DEVIATION REQUEST AND DECISION FORM

Project Name :	The Commons at Falcon Field	Deviation No. 1	Date: 6/2/2023
Schedule No.(s) :	4307000001 and 4307200015		
Legal Description :	TRACT IN SEC 7-13-64 DESC AS FOLS: BEG AT NW COR OF LOT 13 ARROWHEAD ESTATES FIL NO 1; TH S 00<46'12" W 197.28 FT ALG WLY LN OF SD LOT 13 TO A PT, N 41<58'50" W 798.01 FT TO SELY R/W LN OF US HWY 24, TH ALG SD SELY R/W LN ALG ARC OF CUR TO L SD CUR BEING CONCAVE TO NW HAVING A RAD OF 5800.00 FT AN ARC DIST OF 193.53 FT A C/A OF 01<54'42" WHICH CHORD BEARS N 47<22'56" E 193.52 FT, N 46<25'11" E 760.04 FT TO INTSEC SD SELY R/W LN OF US HWY 24 & WLY R/W LN OF RIO LN, TH SLY ALG SD R/W OF RIO LN S 22<22'28" E 219.81 FT, S 89<10'21" E 1071.23 FT TO NW COR OF LOT 14 OF FALCON RANCH ESTATES SUB, S 00<10'51" E 705.04 FT ALG WLY LN OF SD LOT 14 & LOT 13 FALCON RANCH ESTATES SUB TO THE MOST NLY NW COR OF LOT 10 ARROWHEAD ESTATES FIL NO 1, TH CONT S 00<10'51" E 151.74 FT, TH N 88<55'44" W 1314.29 FT TO POB TRACT IN SEC 7-13-64 DESC AS FOLS: COM AT NW COR OF LOT 13 ARROWHEAD ESTATES FIL NO 1; TH S 00<46'12" W 197.28 FT FOR POB; TH CONT S 00<46'12" W 988.14 FT, S 86<00'46" W 327.52 FT, S 00<25'05" W 68.17 FT, N 89<59'43"

Deviation Exhibit A
Deviation Requests

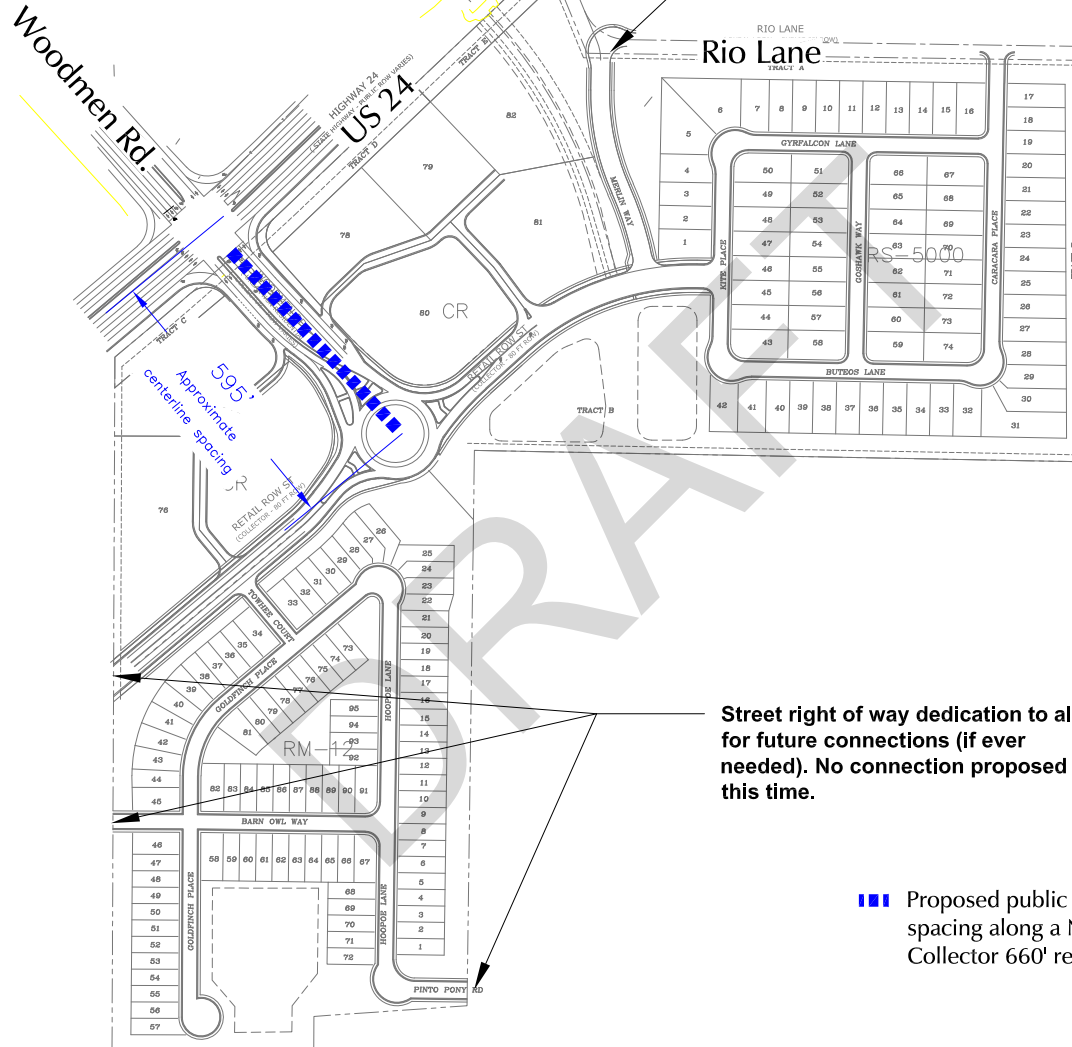
595' shown on the exhibit. Additionally, see comments on the preliminary plan and adjust as necessary.
